DA 202/2016 - 2016HCC014 - 64 Warners Bay Rd Aged Care Facility

Answers to questions raised by Panel Members:

COUNCIL ASSESSMENT REPORT

Panel Reference	2016HCC014
DA Number	DA/202/2016
LGA	Lake Macquarie
Proposed Development	Residential Aged Care Facility
Street Address	Lot 11 DP 656806, Lot 1 DP 515152, Lot 2 DP 515152, Lot 3 DP 515152, Lot 4 DP 515152
	64 Warners Bay Road, WARNERS BAY NSW 2282, 66 Warners Bay Road, WARNERS BAY NSW 2282, 68 Warners Bay Road, WARNERS BAY NSW 2282, 70 Warners Bay Road, WARNERS BAY NSW 2282, 72 Warners Bay Road, WARNERS BAY NSW 2282
Applicant/Owner	BUPA CARE SERVICES PTY LIMITED
Date of DA lodgement	15 February 2016
Number of Submissions	Two
Recommendation	Approval
Regional Development Criteria (Schedule 4A of the EP&A Act)	General development over \$20 million
List of all relevant	Lake Macquarie Local Environmental Plan 2014
s79C(1)(a) matters	Lake Macquarie Development Control Plan 2014
List all documents	Assessment Report
submitted with this report for the Panel's	Proposed conditions of consent
consideration	Plans of development

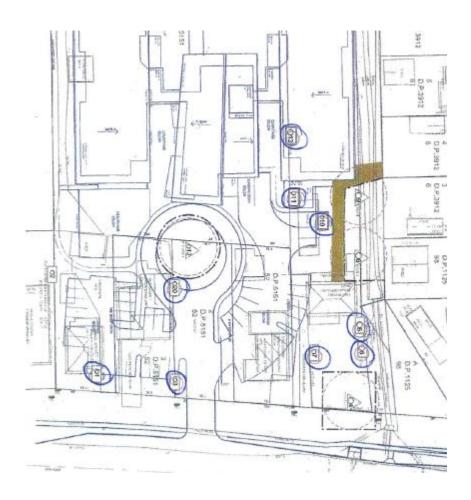
3. Tree planting/removal in the front carpark – the rate per space, any rates within Council's controls (can be at site/prior briefing)

There are a total of nine trees proposed for removal from the site (Trees 1, 3, 5, 6, 7, 10, 11, 13 & 20 in diagram below), seven of these are in front setback and the other two within building footprint. All trees proposed for removal are described in the Arborist Report as being "of low and very low retention value".

There are no specific requirements under LMDCP 2014 Part 3 – Development within Residential Zones, in regards to tree planting within carparking areas.

However (as a guide), under the Business Zone controls there are requirements as follows:

Development must include one advanced clear-trunked broad-canopy tree for every six at-grade car parking spaces.

There are in excess of six broad-canopy trees proposed to the car parking area (37 parking spaces proposed), with Council's Landscape Architect advising that the location of the trees to the west of the parking spaces in particular, adjacent to the green space, would have appropriate space for root volume and potential for growth.
